UNITED STATES PATENT AND TRADEMARK OFFICE

APPLICATION NO.	FILING DATE	FIRST NAMED INVENTOR	ATTORNEY DOCKET NO.	CONFIRMATION NO.
10/089,717	04/02/2002	Robert John Pannekoek	02-313	2705

<b>Office Action Summary</b>	<b>Application No.</b> 10/089,717	<b>Applicant(s)</b> PANNEKOEK, ROBERT JOHN	
	<b>Examiner</b> James M Hewitt	<b>Art Unit</b> 3679

## DETAILED ACTION

P. F. HART  
PIPE CONNECTION  
Filed Feb. 26, 1924

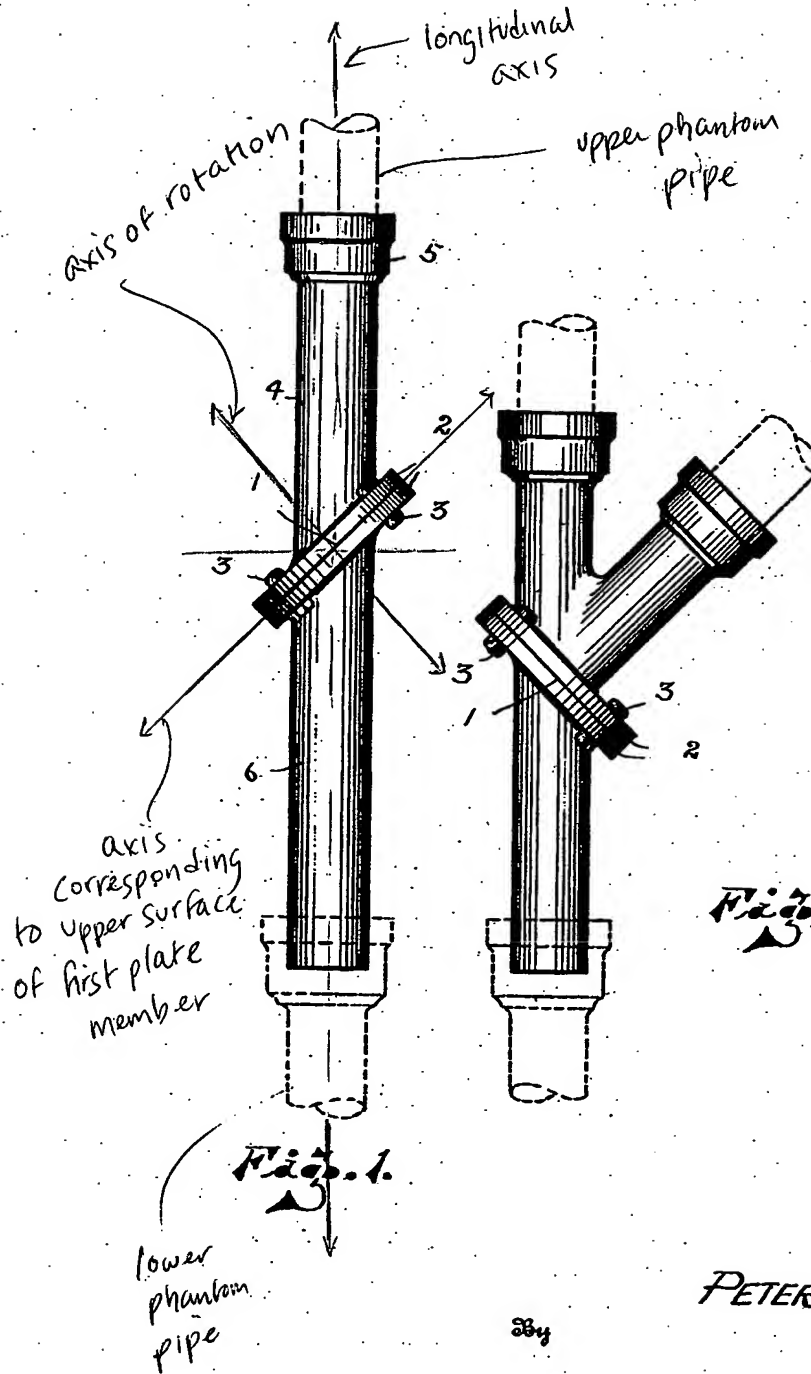
With respect to claim 1, Hart discloses an elongate member for locating an article (in Figure 1, the pipe shown in phantom connected to pipe section 4) remote from a base position (in Figure 1, defined by the pipe shown in phantom connected to pipe section 6), characterized in that the elongate member comprises an inner elongate portion (6), the inner elongate portion extending, in use, from the base position, an outer elongate portion (4), the outer elongate portion being arranged to receive the article, and interconnecting means (flanges 2 and bolts 3), the interconnecting means being arranged to connect the inner elongate portion to the outer elongate portion and to permit relative rotation of the inner and outer portions about an axis of rotation (see Attachment A), the axis of rotation being disposed at an acute angle (45 degrees; see lines 52-53) relative to a longitudinal axis (see Attachment A) of the inner elongate portion.

Elongate portion (6) is considered to be "inner" in that it is situated more closely to the lower pipe shown in phantom. Elongate portion (4) is considered to be "outer" in that it is situated further from the lower pipe shown in phantom relative to portion (6).

Loosening or removal of bolts (3) would permit relative rotation of the inner and outer portions about the axis of rotation.

With respect to claim 2, wherein the outer elongate portion (4) is arranged to move between a first position (shown in Figure 1) whereby the outer elongate portion is substantially coaxial with the inner elongate portion and a second position whereby the outer elongate portion is substantially perpendicular to the inner elongate portion.

The outer elongate portion, after loosening or removal of the bolts (3) and rotating the outer portion and its flange 180 degrees relative to the inner portion and its flange, would be oriented perpendicular to the inner elongate portion. The bolt holes, as they are symmetrical about their respective flanges (2), would be aligned, and the bolts could be re-engaged therein to secure the outer elongate portion to the inner elongate portion.

With respect to claim 4, wherein the interconnecting means includes a first plate member (flange 2) fixedly attached to the inner elongate portion (6) at an end remote from the base position, and a second plate member (flange 2) fixedly attached to the outer elongate portion (4) at an end remote from the article wherein, in use, the first plate member is located adjacent the second plate member (see Figure 1).

With respect to claim 5, wherein the first plate member has an upper surface and the second plate member has a lower surface, the upper surface of the first plate member being adjacent the lower surface of the second plate member in use, and the axis of rotation being perpendicular to the upper surface of the first plate member (see Attachment A).

With respect to claim 6, wherein the interconnecting means includes a fixing means (bolts 3), the fixing means being arranged to releasably engage the first plate member and the second plate member such that, in use, when the first and second plate members are engaged by the fixing means, relative rotation of the outer and inner elongate portions is restricted.

With respect to claim 8, wherein the first plate member has at least one aperture (a bolt hole), and the second plate member has at least one aperture (a bolt hole), and wherein the aperture of the first plate member is adjacent to the aperture of the second plate member when the inner elongate portion and the outer elongate portion are arranged in a particular position (e.g. the position shown in Figure 1), and wherein the interconnecting means includes a pin member (a bolt 3) arranged, in use, to locate within the aperture of the first plate and the aperture of the second plate and thus restrict relative rotation of the inner elongate portion and the outer elongate portion.

Rotating the outer portion and its flange 180 degrees relative to the inner portion and its flange, would cause a bolt hole of the first plate member, which prior to rotation would be initially adjacent one bolt hole of the second plate member, to be subsequently, after rotation, adjacent a second bolt hole of the second plate member.

FIG. 2

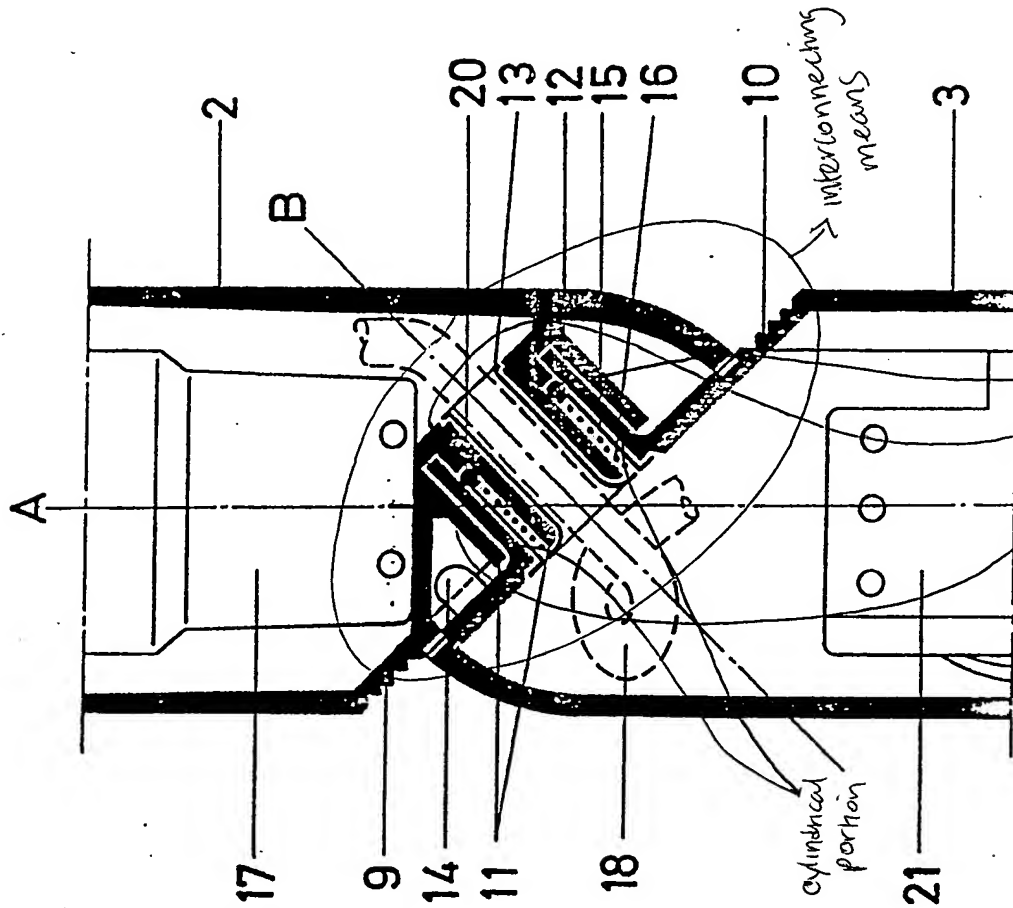
With respect to claim 1, Jendrewski et al discloses an elongate member for locating an article (1) remote from a base position (the ground or earth), characterized in that the elongate member comprises an inner elongate portion (parts 3 and 4), the inner elongate portion extending, in use (when ground stake 28 has been inserted into the ground), from the base position, an outer elongate portion (2), the outer elongate portion being arranged to receive the article (see Figure 1), and interconnecting means (see Figures 2 and 4 and Attachment B), the interconnecting means being arranged to connect the inner elongate portion to the outer elongate portion and to permit relative rotation of the inner and outer portions about an axis of rotation (B), the axis of rotation being disposed at an acute angle relative to a longitudinal axis (A) of the inner elongate portion (see Figures 2 and 4).

Elongate portion (3/4) is considered to be "inner" in that it is situated more closely to the stake or ground, when in use. Elongate portion (2) is considered to be "outer" in that it is situated further from the stake or ground relative to portion (3/4).

With respect to claim 10, wherein the interconnecting means includes a cylindrical portion arranged to be coaxial with the axis of rotation, and wherein the cylindrical portion extends from the inner elongate portion and wherein the outer elongate portion includes an aperture arranged to receive the cylindrical portion. Refer to Figure 2 and Attachment B.

this structure forms an aperture which holds/houses the cylindrical portion
